I-70 West Vail Pass Auxiliary Lanes
Eagle County, Colorado
Value Engineering Study Report - Final

R | 0
May 20, 2021

Project: NHPP 0702-404 / FBR 0702-403
Subaccount: 23982 / 23929

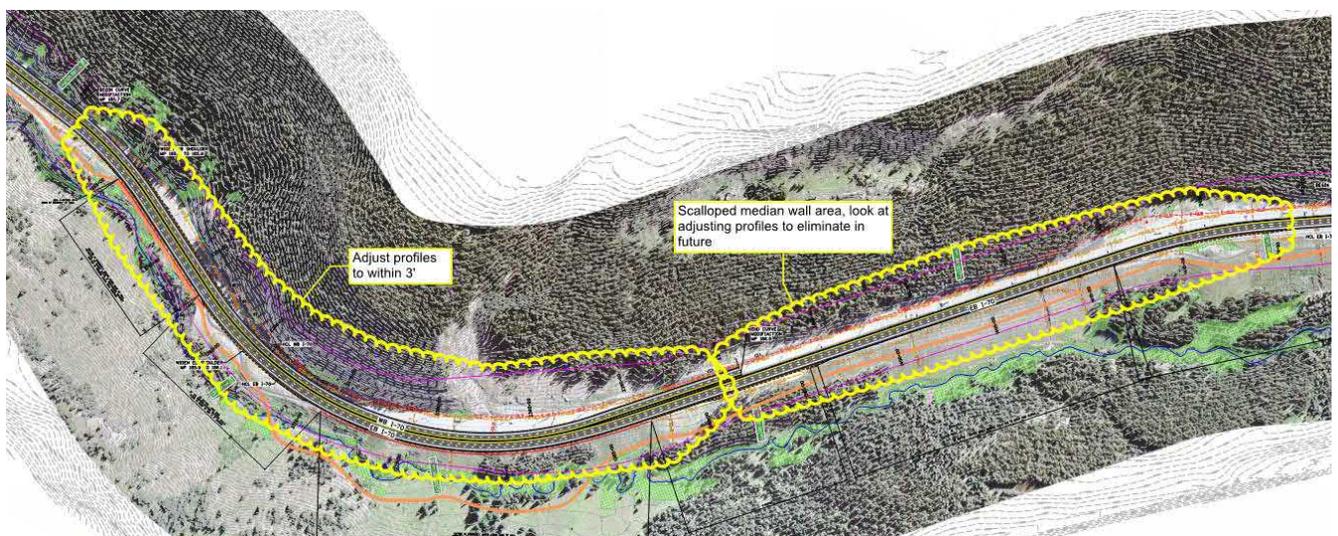
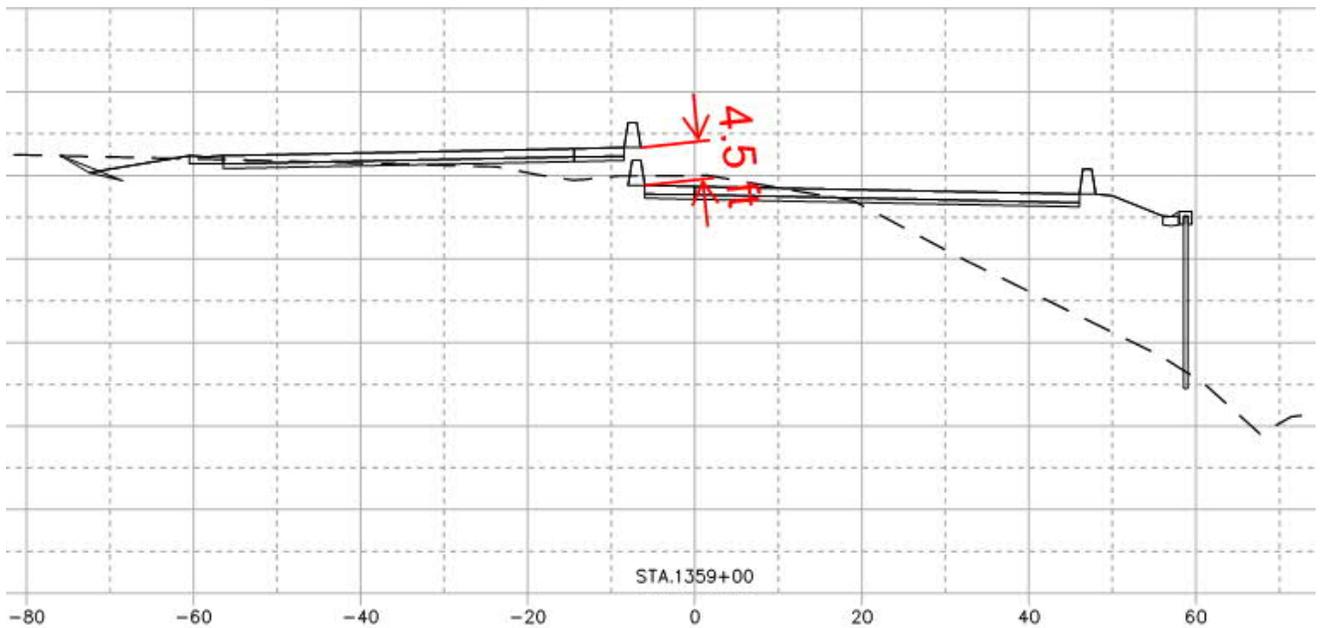
The proposal is to raise the EB profile (or lower WB, or a combination) to keep the inside edges within 3' so Type 9 Style CE offset barrier can be used without the need for median retaining walls. In some areas, an outside retaining wall is already proposed, which would increase in height and resultant cost, but adding height to an already moderate height wall is likely less costly than building a wall in the narrow median. Profile adjustments are proposed to be applied at the following locations within the INFRA Grant project (similar approach could be taken for ultimate):

- 1355+00 – 1361+00, raise of 0'-1.5', outside MSE Wall would increase in height
- 1361+00 – 1365+00, raise of 0'-0.6, in cut, excavation would be reduced, reducing waste
- 1380+00 – 1385+00, raise of 0'-1', outside MSE Wall would increase in height

In the existing median scalloped walls section from M.P. 186.6 to 187, profile should be adjusted to preserve these in the interim, and the ultimate design should be reviewed to see if a combination of raising EB and lowering WB could eliminate the need to reestablish the scalloped walls in the future if a simple grass slope median can be established.

The proposal will be considered in the INFRA Grant scope design. The proposal is accepted with modifications.

Drainage at STA 1512+00 for possible retrofit

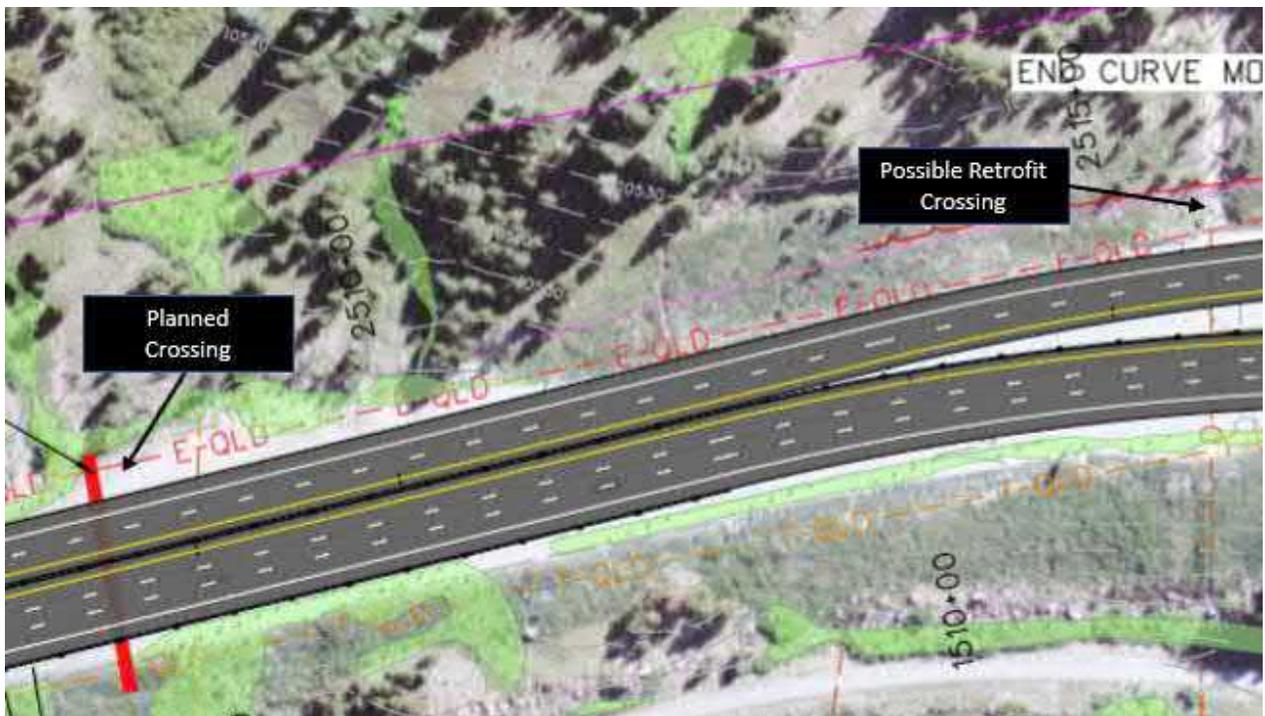
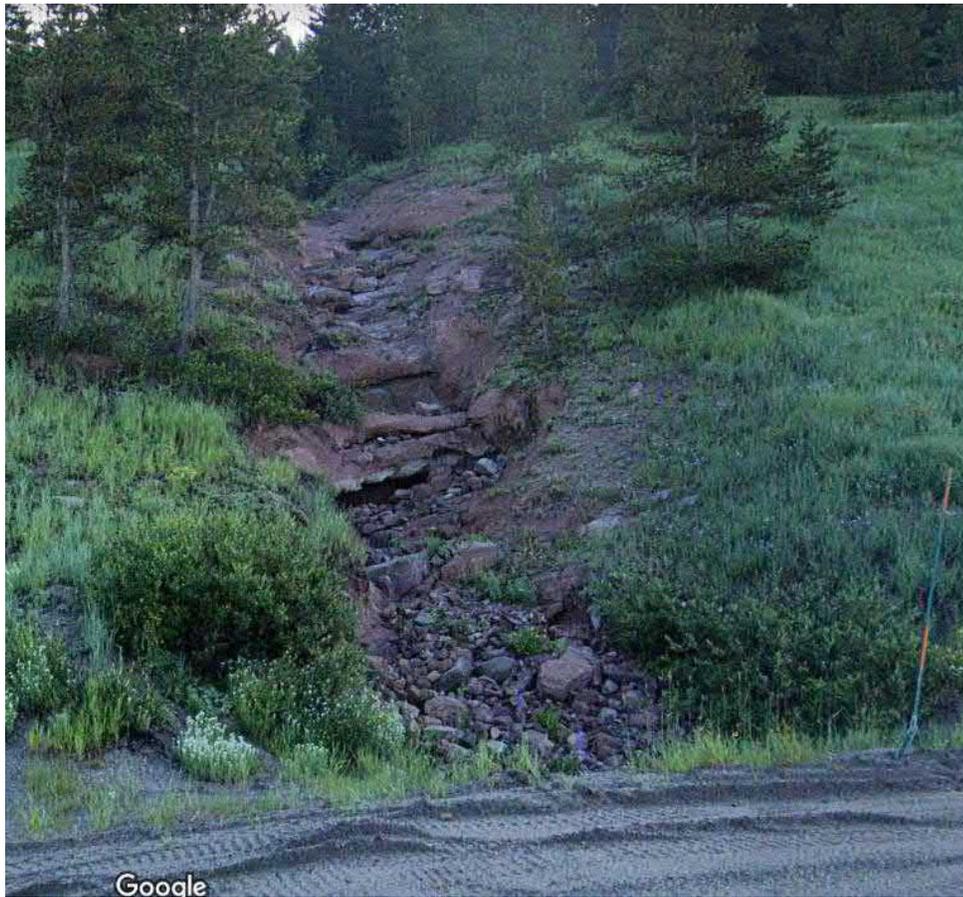
The current design requires installing new structures in six locations to provide wildlife crossing opportunity. A culvert inventory should be conducted to determine if existing cross culverts are sized appropriately and/or can be retrofitted to meet the intent of providing wildlife passage. Ideally the retrofit of an existing structure would replace the need for a new stand-alone structure. Examples:

A specific example would be to retrofit the existing crossing at STA 1512+00 instead of placing a new structure at STA 1505+00.

Idea 38

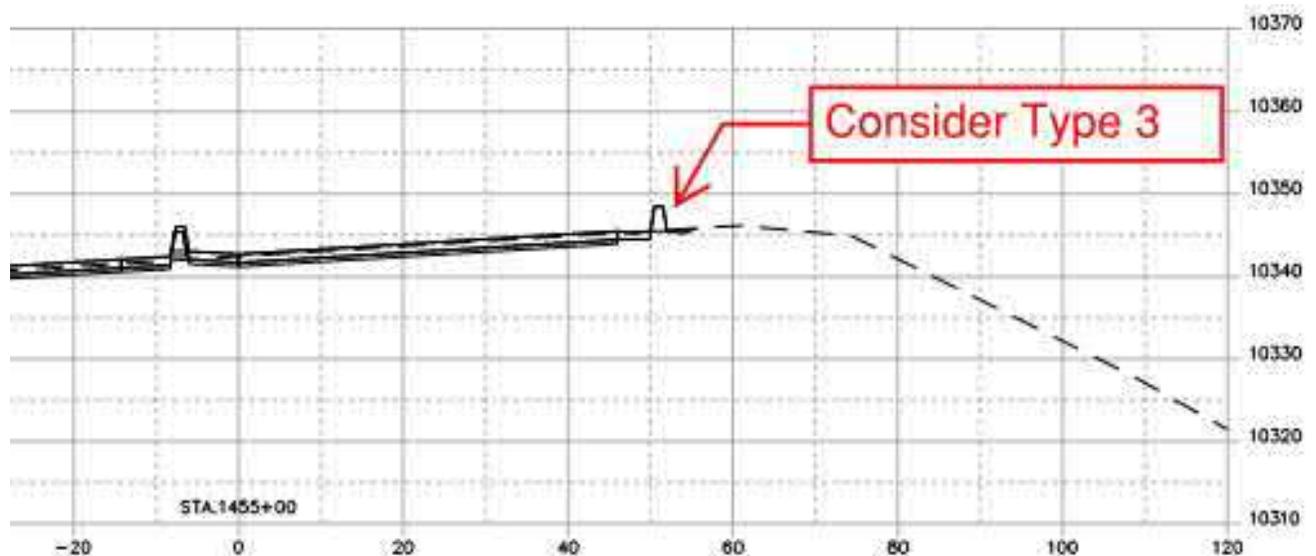
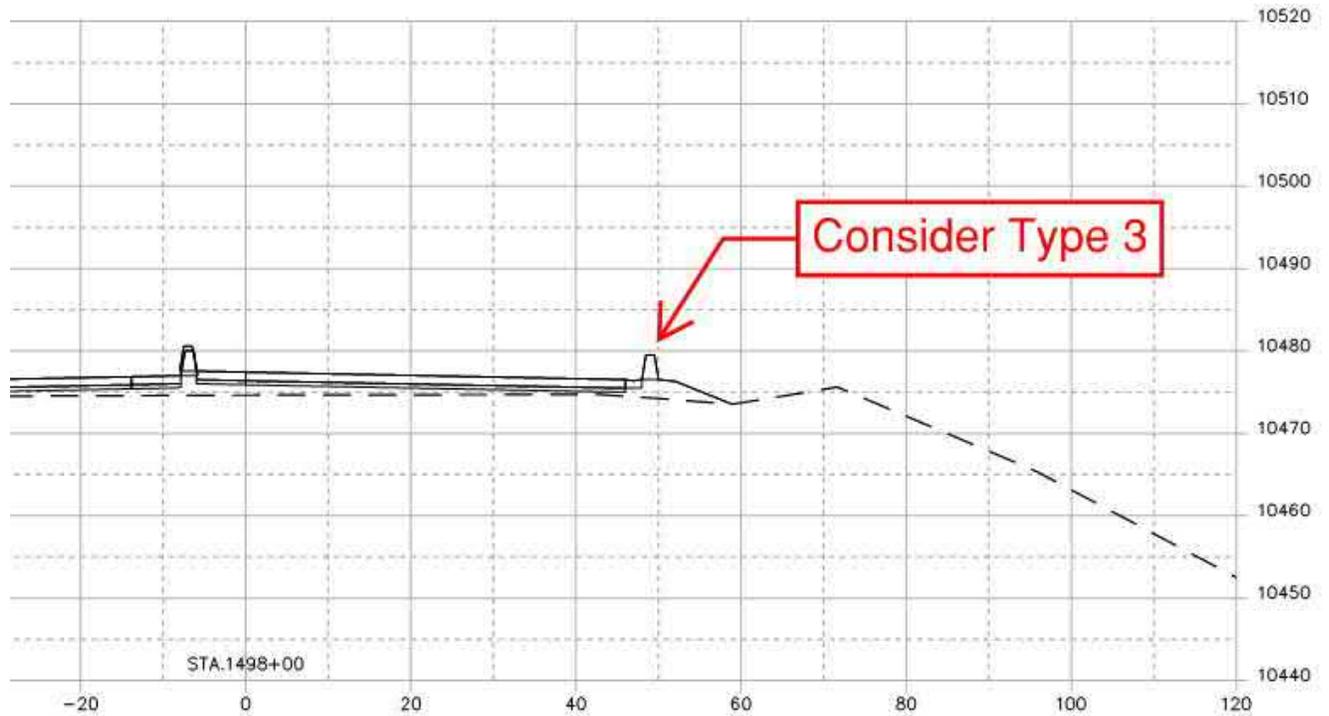
The proposal is to utilize metal Type 3 guardrail in lieu of concrete Type 9 barrier in the following situations:

- High or left side of EB pavement where solid barrier is not needed to retain fills from WB lanes
- Right side of EB pavement where barrier is shown adjacent to ditch sections, or sufficient bench exists beyond the barrier to accommodate drainage which comes through the Type 3 guardrail.

Idea 17

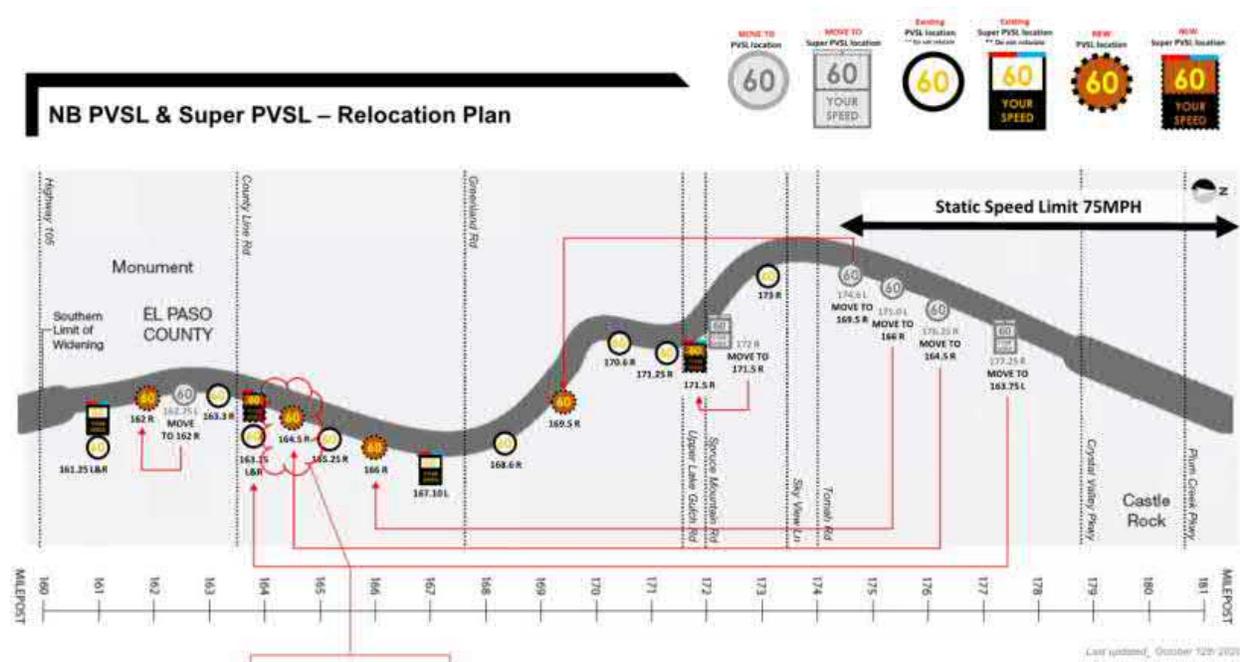
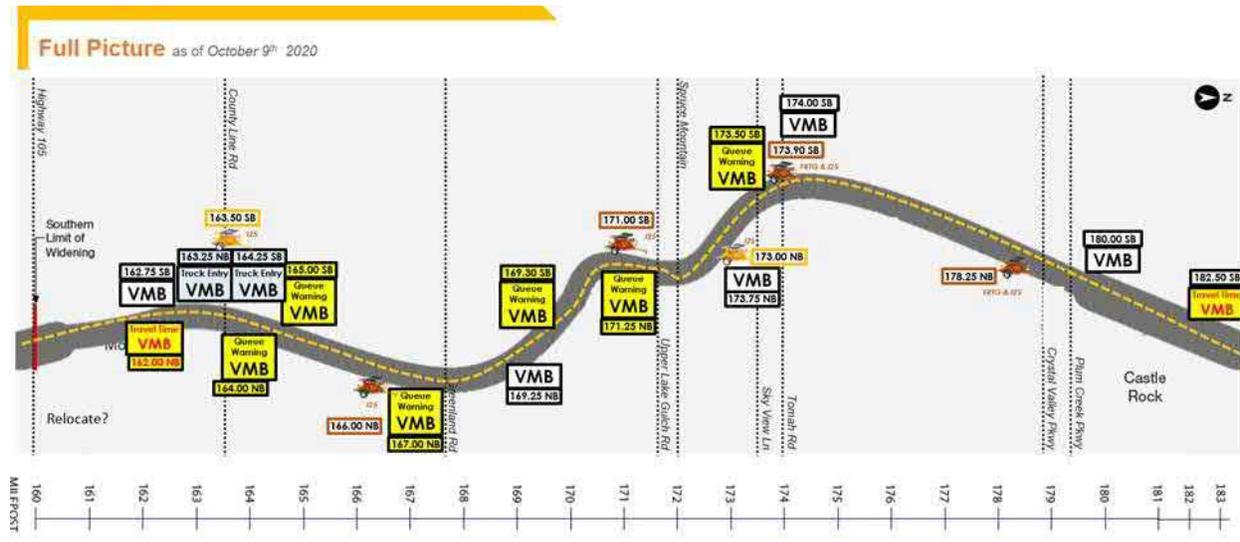
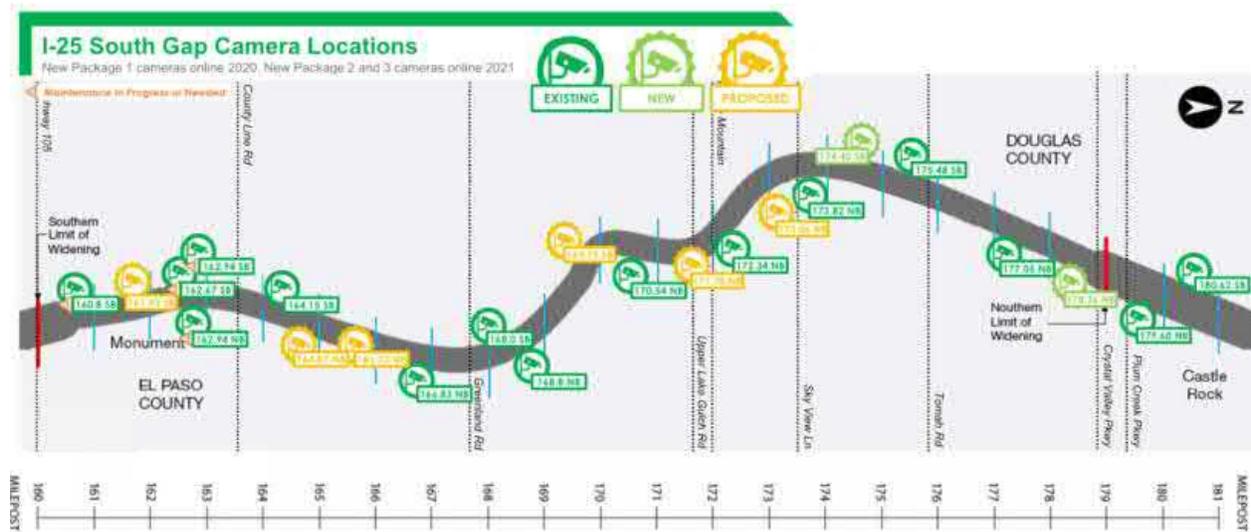
Several goals of the project are to be able to alert motorists of delays, perform quick closure of the highway, capacity improvements and safety. It is possible to maintain these goals during construction by using Smart Work Zone (SWZ) technology. This is used on the current \$350 million CMGC CDOT i-25 gap project between Castle Rock and Monument and is showing good results by reduced accidents and quick response times. The noted project has 2 years of experience using this technology and has a fully operational satellite project operations office to control the equipment staffed for the core work hours. The SMZ equipment (see below for examples of signs and SWZ deployment maps) are portable rented trailers that can be saleable to any project length and size using a customer off the shelf software. The system is provided by a vendor called Street Smart and can be set up in weeks and be fully operational without the need for power and communications. The equipment is solar and uses a local cellular network. It is unknown how it would perform however on Vail pass in less than ideal conditions. The SWZ equipment can include a variety of devices such as variable speed limits, travel time, queue warning for slowdowns, programmable message boards, closed circuit TV, road and weather information systems, automated flagging systems, temporary signals, remote controlled beacons, etc. On a typical construction project, the ability to remotely control portable devices is not widely used and delays for notices causes driver frustration and additional congestion. The ability to control remotely would be invaluable.

Figure 1 - I-70 High Voltage and Secondary

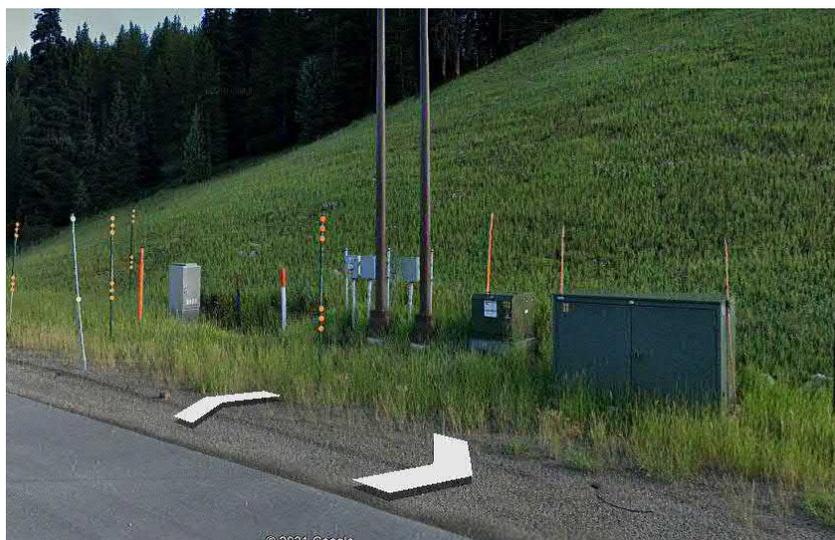
When the I-70 fiber was extended to the town of Vail, Xcel approached CDOT and proposed a joint trench which would include a high voltage line in the I-70 right of way from Copper Mountain to the Vail Rest Area. This area often experienced power outages due to unreliable and outdated overhead power. CDOT partnered with Xcel and shared the joint trench. CDOT provided a design, bid, build set of plans and one contractor built the project for both CDOT and Xcel. This was considered a public private partnership but since Xcel is a utility it was not necessary to complete a RFP for this work and a simple contract was drafted by CDOT and Xcel. The joint trench (fiber and high voltage line) has break out boxes for the fiber and power to avoid electrocution and secondary services as needed by CDOT for power along the highway.

This proposal is to continue the high voltage line to the town of Vail if desired by Holy Cross power and Xcel Energy; which have not been approached with this idea. The full ITS plan for VSL's, LUS's, etc will require power and it is intermittent on the west side of the pass. It is uncertain how much of the fiber backbone is to be moved and can remain. In the areas where the backbone is moved, it may make sense to partner with the local power company and in other areas it may be beneficial to allow a utility trench for power under the public private partnership guidelines. Below is an example of the many high voltage and secondary service boxes along I-70 between Copper Mountain and the top of Vail Pass. The CDOT ITS Branch has the design plans for this work.

Figure 1 FIR/FOR plan sheet 104 of 174 shows crank arm on gate

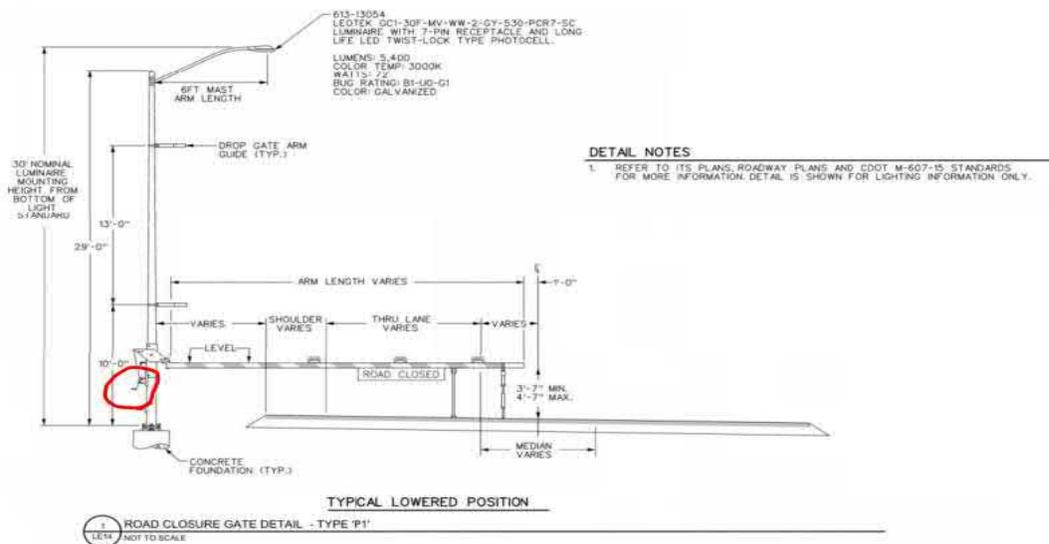
This proposal is to change the current design from a manually lowered road closure gate to an automated closure gate for both directions of I-70 and the on-ramps. This technology is used by the railroads and in Denver on the I-25 HOV lanes. While road closures are maintained by the DOT, when in place an automated closure would allow quicker opening of the highway but not necessarily for closing since these are manned locations by state personnel due to drivers possibly going around the gates. However, during opening an automated system could alleviate some personnel the burden of sitting on the highway before an opening. In addition, the gates can at times be difficult to lower due to inclement weather, i.e. snow, wind, and ice. An enclosure system would ensure the gates are lowered in all weather conditions. This proposal will require fiber connectivity and software development to remotely control the gates by the traffic operations center(s).
